H. B. ROBINSON UNIT 2
FACILITY OPERATING LICENSE DPR-23
APPLICATION FOR OPERATION AT 2300 MWt CORE POWER

REVISIONS TO TECHNICAL SPECIFICATIONS

H. B. ROBINSON UNIT NO. 2

2300 MWt CORE POWER OPERATION

Figure 2.1-1
Protection Boundaries
N-Loop Operation

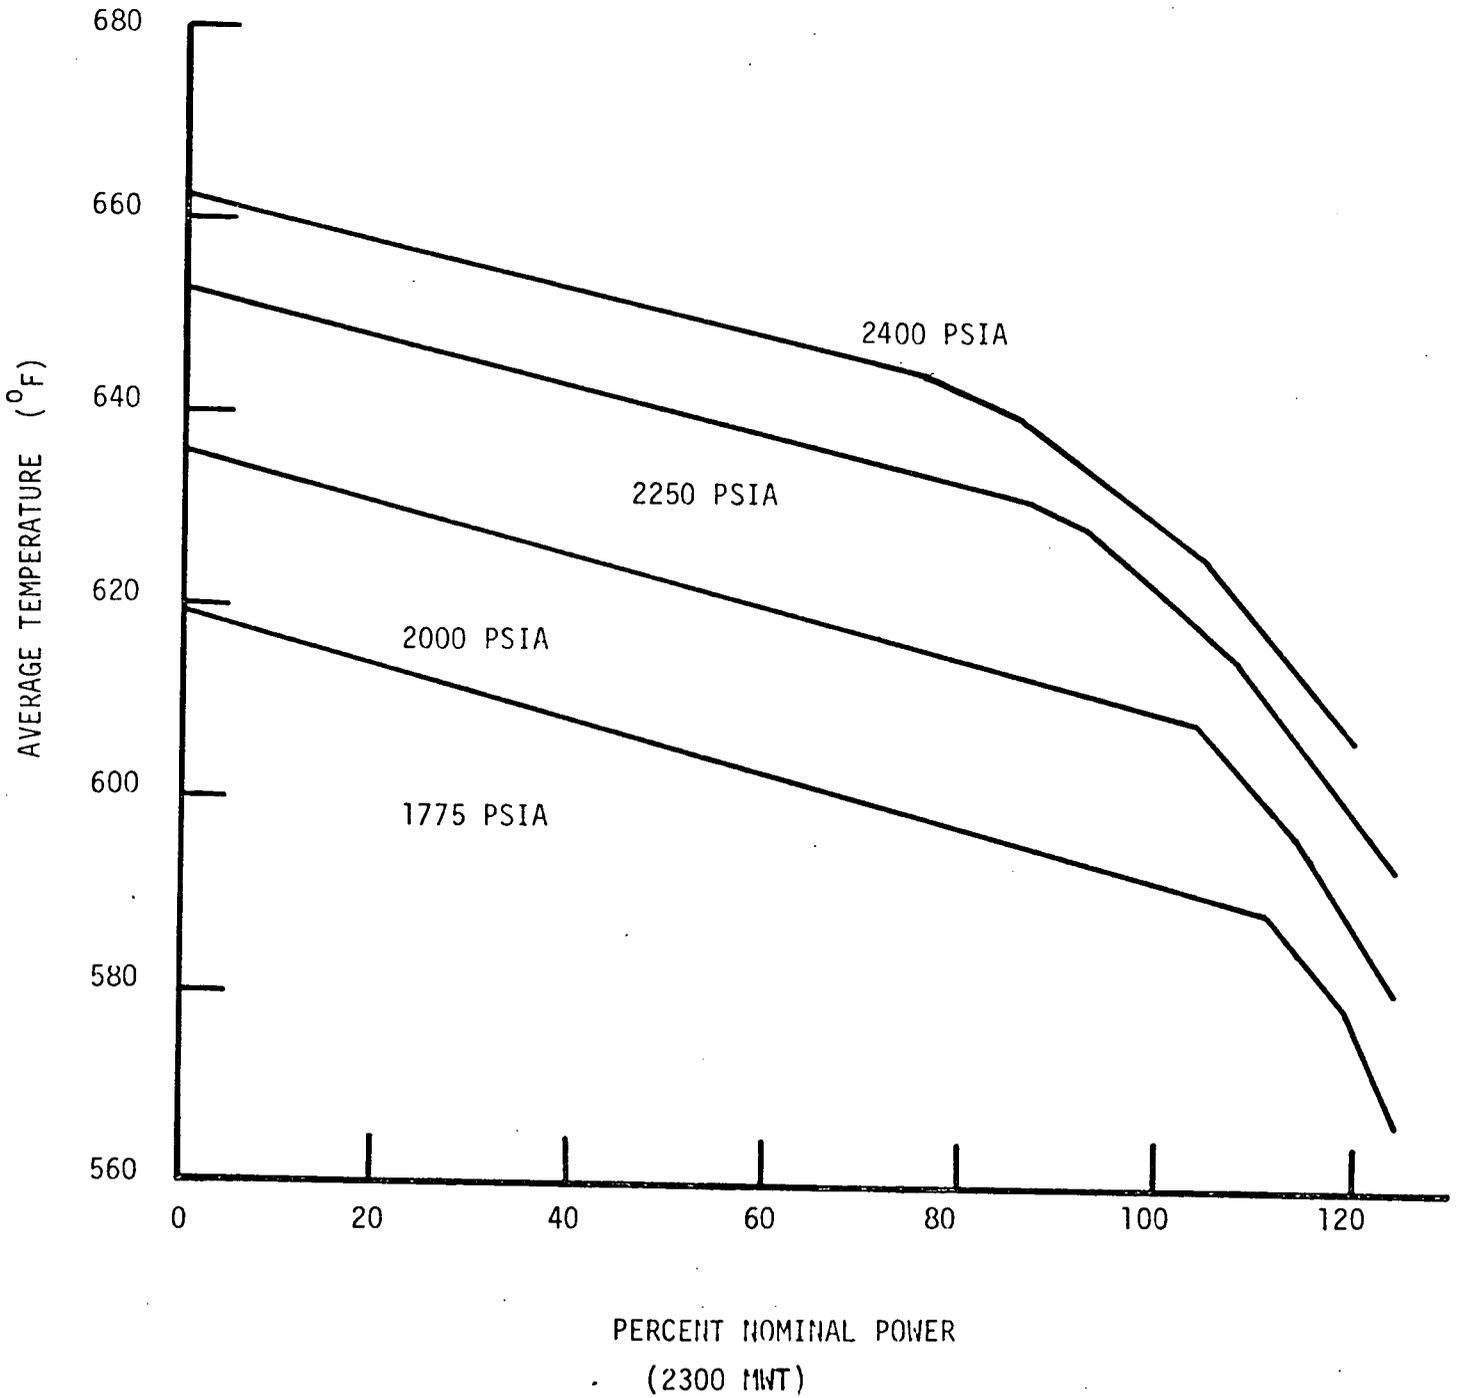
The curves of Figure 2.1-1 which show the allowable power level decreasing with increasing temperature at selected pressures for constant flow (three loop operation) represent the loci of points of thermal power, coolant system average temperature, and coolant system pressure for which the DNB ratio is not less than 1.30. The area where clad integrity is assured is below these lines. In order to completely specify limits at all power levels, arbitrary constant upper limits of average temperature are shown for each pressure at powers lower than approximately 75%. The temperature limits at low power are considerably more conservative than would be required if they were based upon a minimum DNB ratio of 1.30 but are such that the plant conditions required to violate the limits are precluded by

The curves of Figure 2.1-2 which show the allowable power level decreasing with increasing temperature at selected pressures for constant flow (two loop operation) represent the loci of points of thermal power, coolant system average temperature, and coolant system pressure for which either the DNB ratio is equal to 1.30 or the average enthalpy at the exit of the core is equal to the saturation value. At low pressures or high temperatures the average enthalpy at the exit of the core reaches saturation before the DNB ratio reaches 1.30 and, thus, this arbitrary limit is conservative with respect to maintaining clad integrity. In order to completely specify limits at all power levels, arbitrary constant upper limits of average temperatures are shown for each pressure at powers lower than approximately 40%. The limits at low power as well as the limits based on the average enthalpy at the exit of the core are considerably more conservative than would be required if they were based upon a minimum DNB ratio of 1.30. The plant conditions required to violate these limits are precluded by the protection system and the self actuated safety valves on the steam generator. An upper limit of 70% for power is shown to completely bound the area where clad integrity is assured. This latter limit is arbitrary but cannot be reached due to the permissive 8 protection system setpoint which will trip the reactor on high nuclear flux when only two reactor coolant pumps are in service. Additional peaking factors to account for local peaking due to fuel rod axial gaps and reduction in fuel pellet stack length have been included in the calculations of the curves shown in Figures 2.1-1 and 2.1-2. The figures also include the effects of uprating to 2300 MWt. (4)

The overpower and overtemperature protection system setpoint have been revised to include effects of fuel densification and the increase in rated thermal output to 2300 MWt on core safety limits. The revised setpoints in the Technical Specifications insure the combination of power, temperature, and pressure will not exceed the core safety limits as shown in Figures 2.1-1 and 2.1-2.

Figure 3.10-2

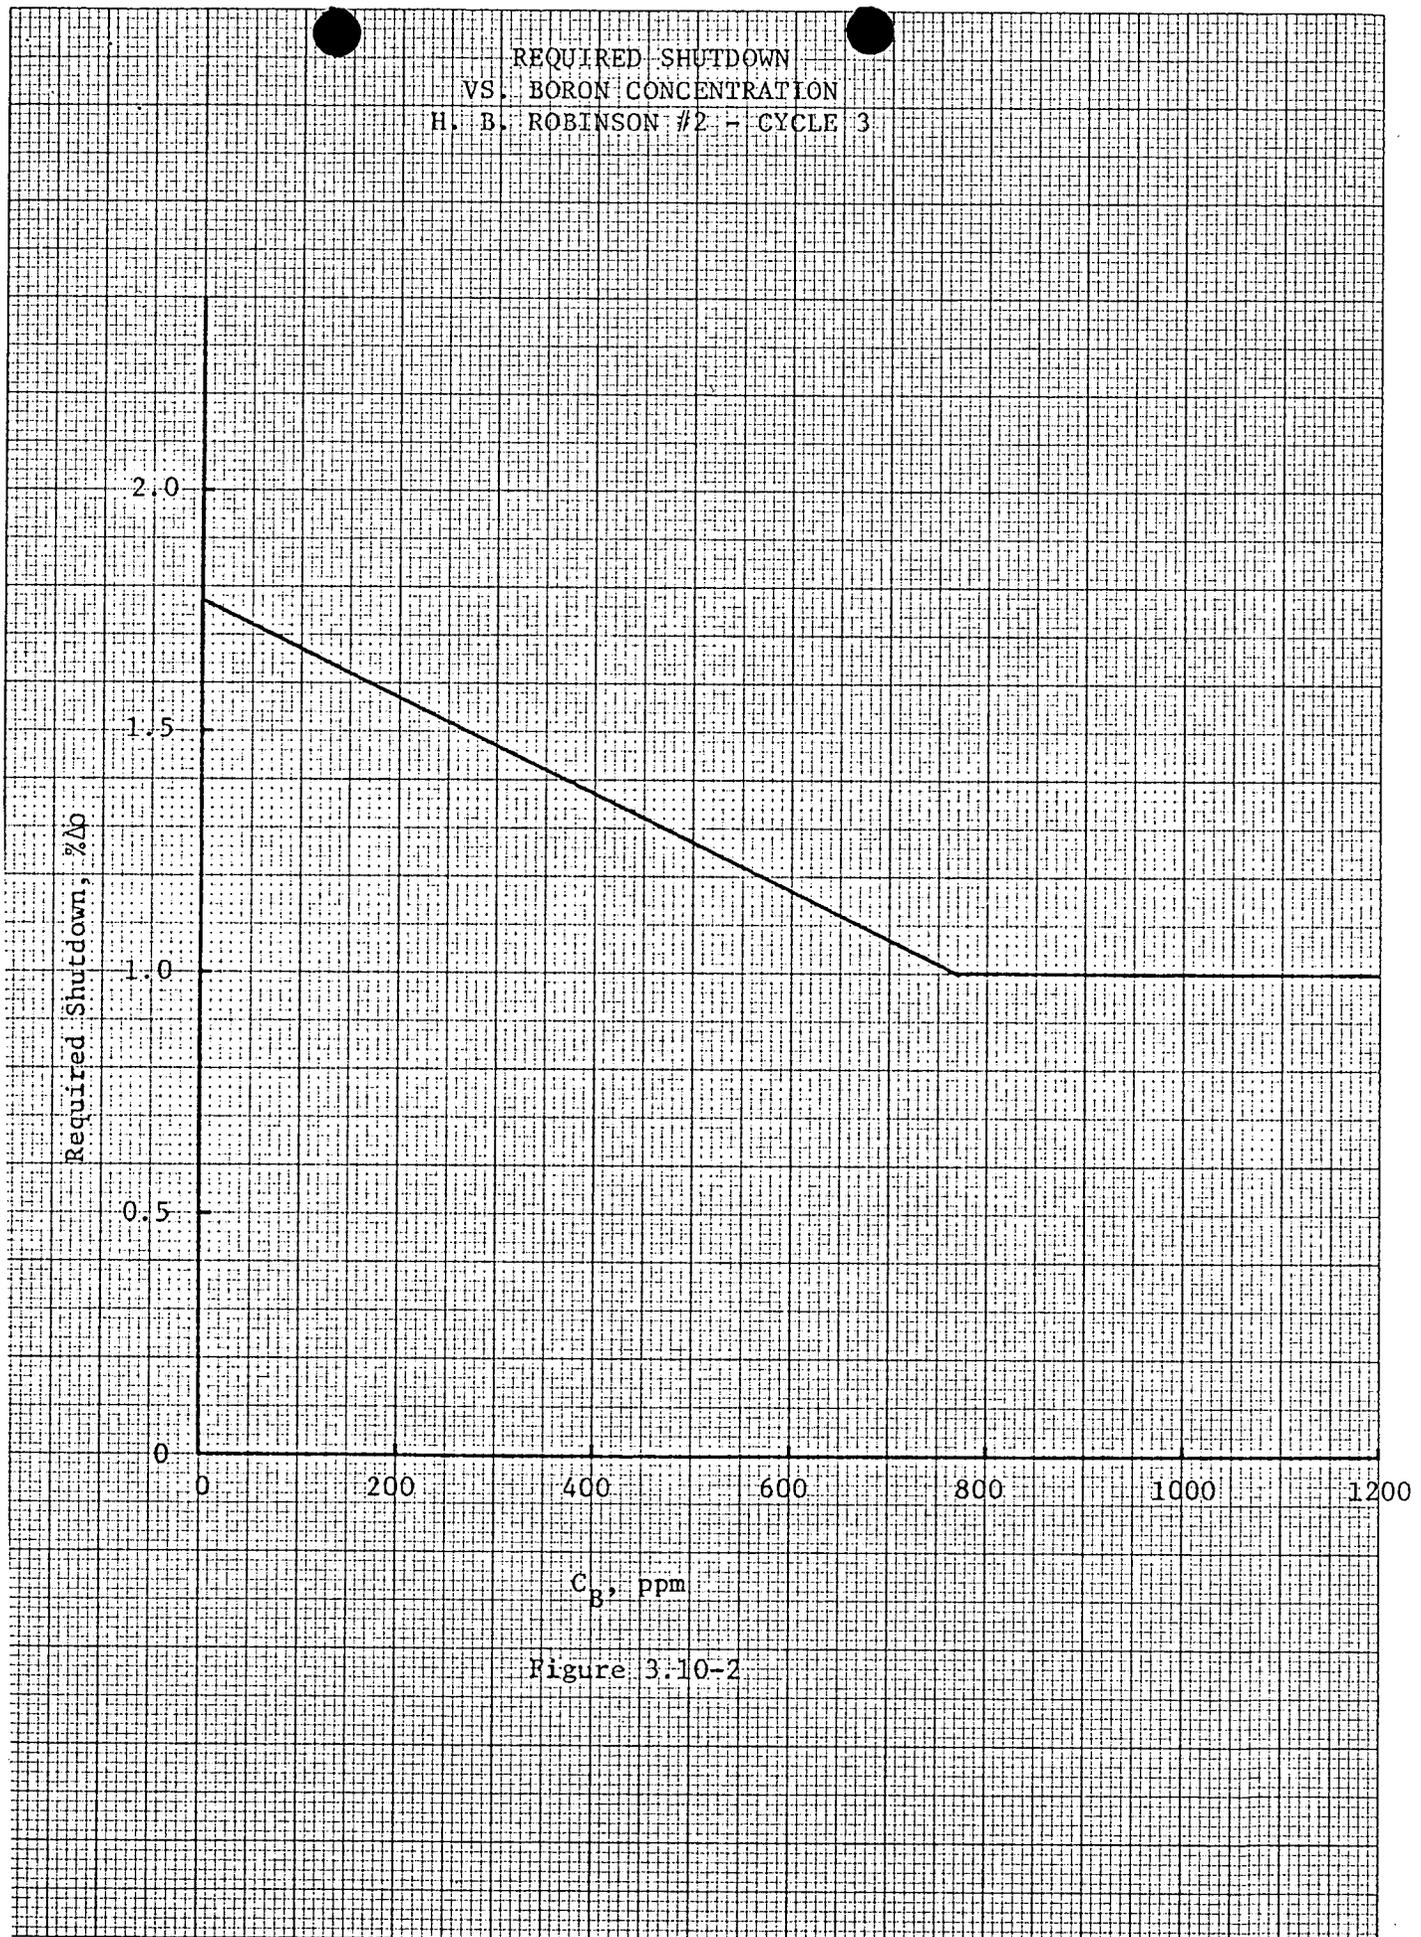
- 3.10.8.1 When the reactor is in the hot shutdown condition, the shutdown margin shall be at least that shown in Figure 3.10-2.
- 3.10.8.2 When the reactor is in the cold shutdown condition, the shutdown margin shall be at least 1% $\Delta k/k$.
- 3.10.8.3 When the reactor is in the refueling operation mode, the shutdown margin shall be at least 10% $\Delta k/k$.

Figure 3.10-3
Power Spike Factor Versus Elevation

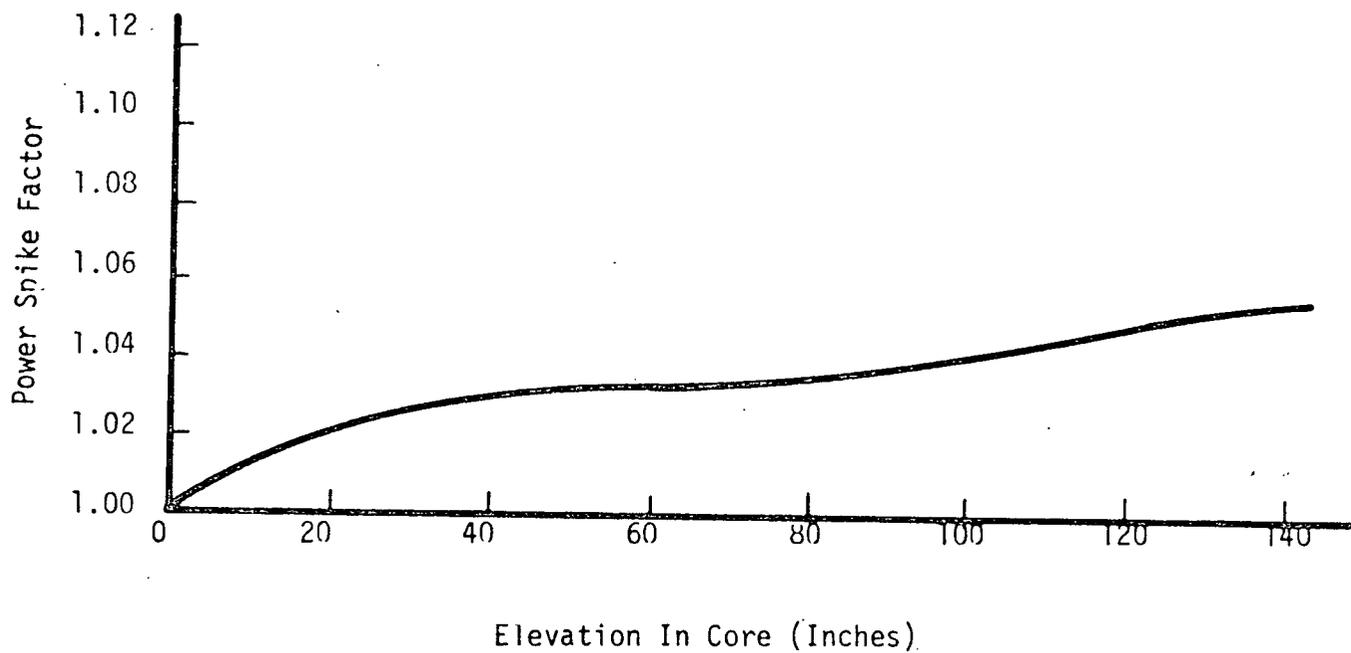
The measured value of F^N must be additionally corrected by including a penalty as shown in Figure 3.10-3 (at the appropriate core location) to account for fuel densification effects before comparison with the limiting value above.
